# Bethesda Downtown Design Advisory Panel (DAP)

Project Name	The Avondale
File Number(s)	320200050, 120200220
Project Address	4526-4530 Avondale Street

CONSOLIDATED SKETCH PLAN & PRELIMINARY PLAN  
DESIGN ADVISORY PANEL SUBMISSION  
JULY 8, 2020

## JUNE 2020 DAP MEETING SUMMARY

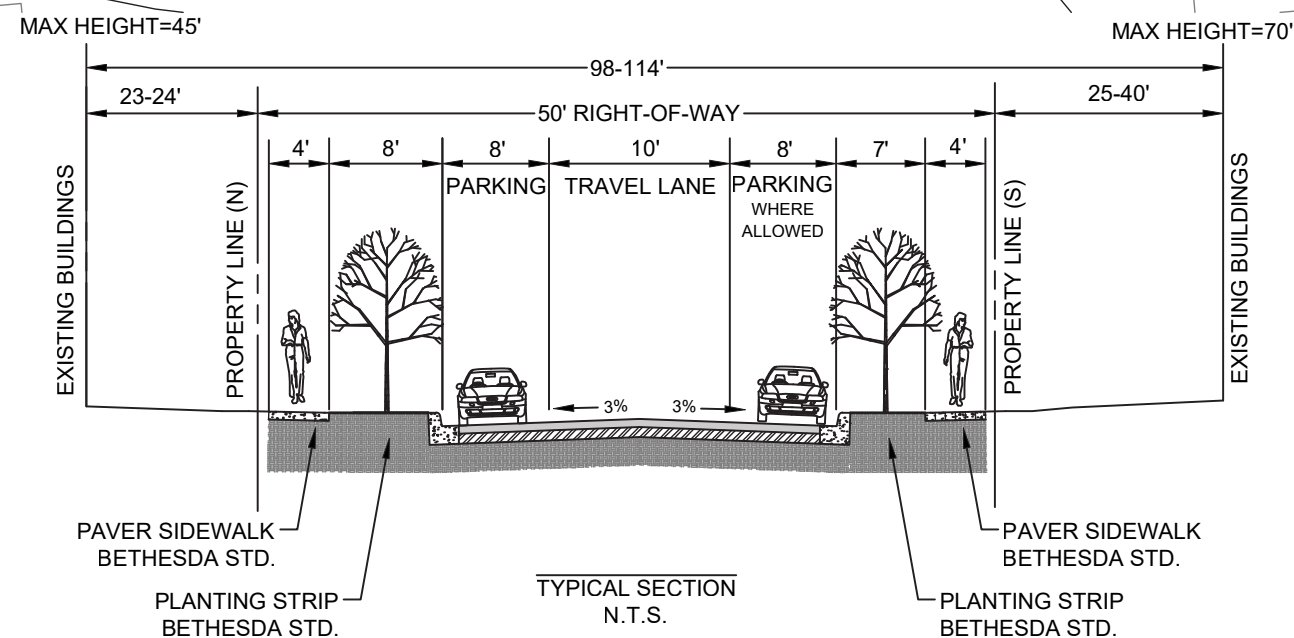
DAP ENCOURAGED EXPLORATION OF OPTIONS THAT DID NOT CONFORM TO THE DESIGN GUIDELINES RECOMMENDATION FOR A 2-STY PROJECTING BASE.

TOWER STEP-BACK ABOVE TWO STORY BASE IS LESS THAN THE 15-20FT STEP-BACK RECOMMENDED IN THE DESIGN GUIDELINES. PROPOSED STEP-BACK VARIES BETWEEN 8FT AT THE PRIMARY BUILDING FACES AND 11FT AT THE SETBACK

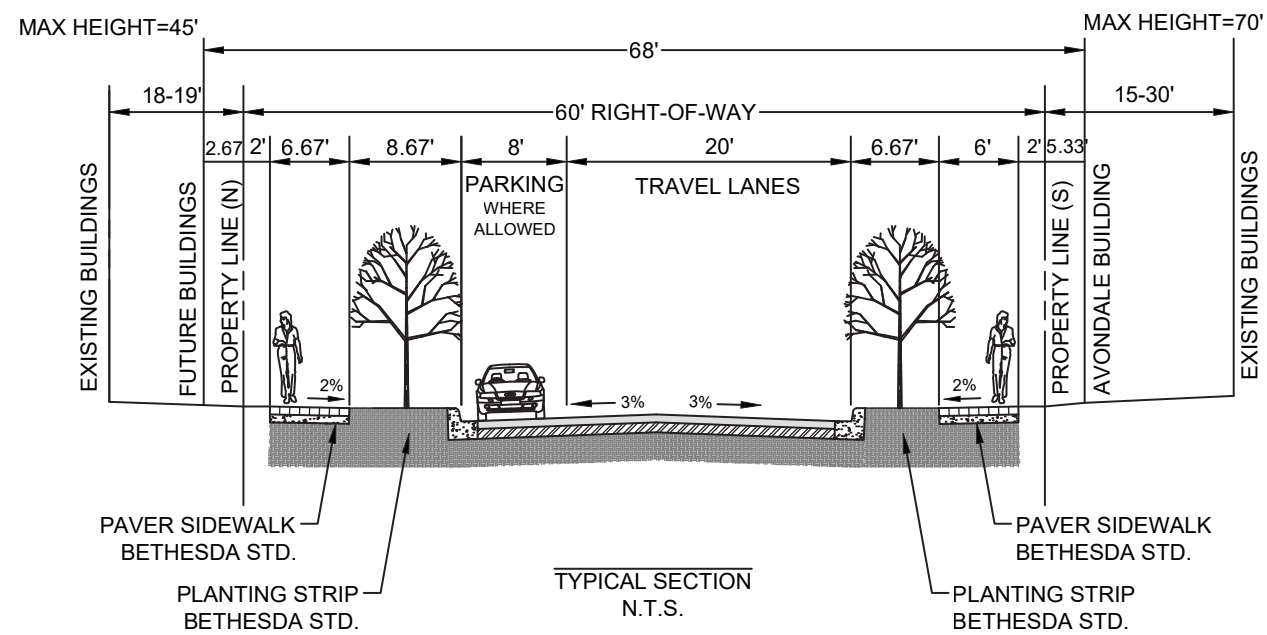
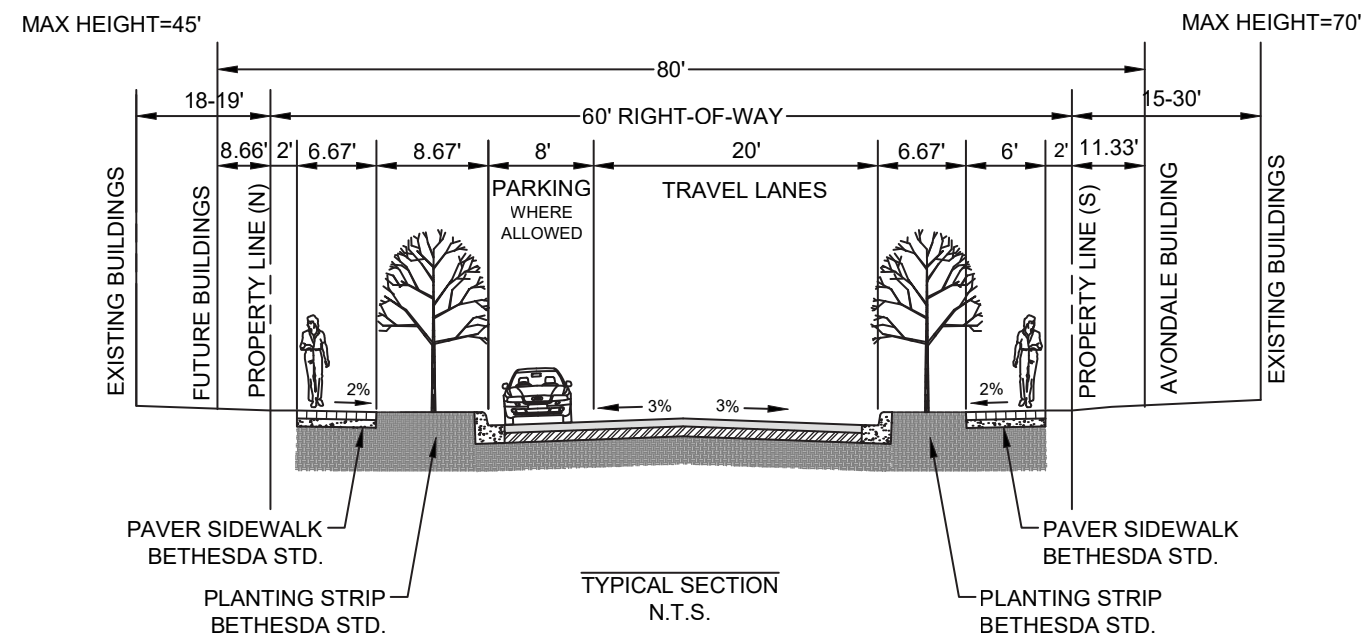
DAP ENCOURAGED EXPLORATION OF OPTIONS THAT DID NOT PROJECT THE LOBBY BEYOND THE BUILD-TO LINE. THE PANEL ALSO ENCOURAGED STUDYING OPTIONS THAT LOCATED THE ENTRANCE IN THE MIDDLE OF THE BUILDING

THE ENTRANCE LOBBY OF THE BUILDING PROJECTS APPROXIMATELY 5FT BEYOND THE BUILD-TO LINE AS A CRISPLY DETAILED "GLASS BOX" THAT DISTINGUISHES THE ENTRANCE TO THE BUILDING AS A SPECIAL ARCHITECTURAL ELEMENT AND ADDS VISUAL INTEREST AT THE PEDESTRIAN SCALE. THE GUIDELINES ALLOW FOR EXCEPTIONS TO BUILDING PLACEMENT GUIDELINES FOR ENTRANCES AND FOR THE PURPOSE OF CREATING ARCHITECTURAL INTEREST.
